A	08.01.26	Planning Amendment	JB
Rev.	Date	Details	By
Client			
Owner

Project Name
120 Archway

Drawing Title
Proposed GA & Setting Out Plan - Roof

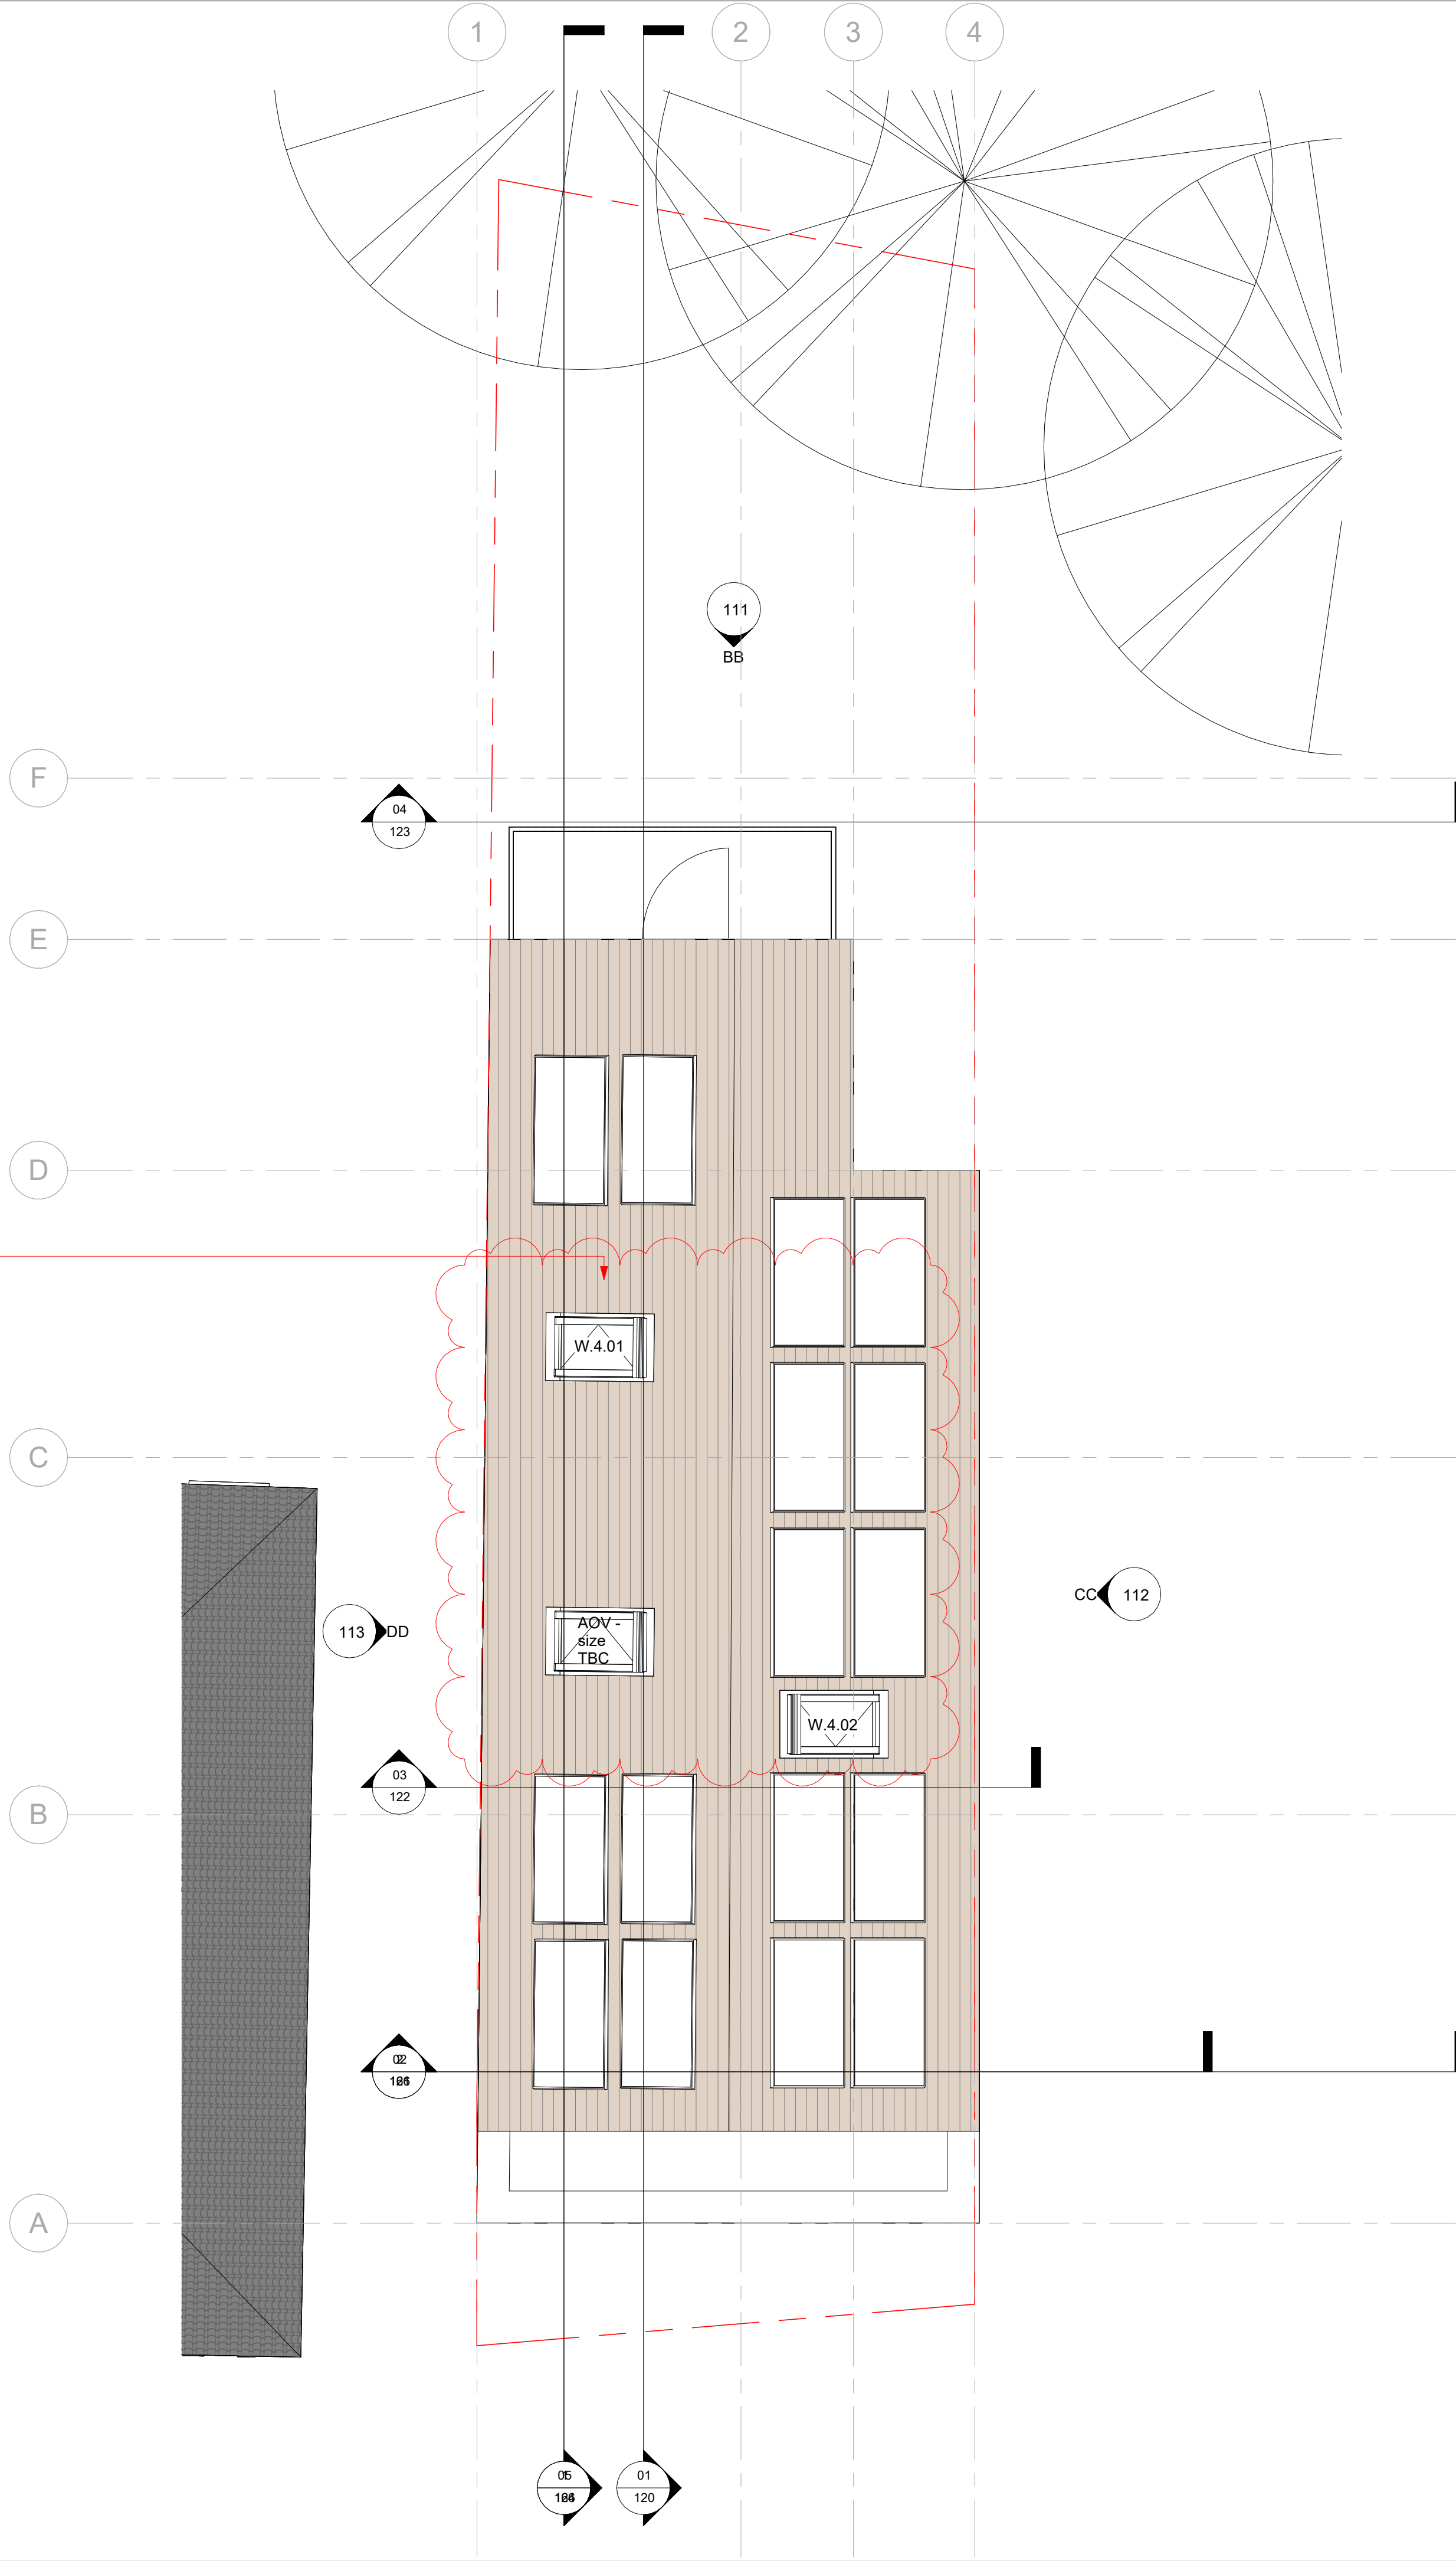
INTRODUCTION OF 2NO. ROOF LIGHT
AND 1NO. AUTOMATIC OPENING VENT
(AOV) FOR FIRE SAFETY
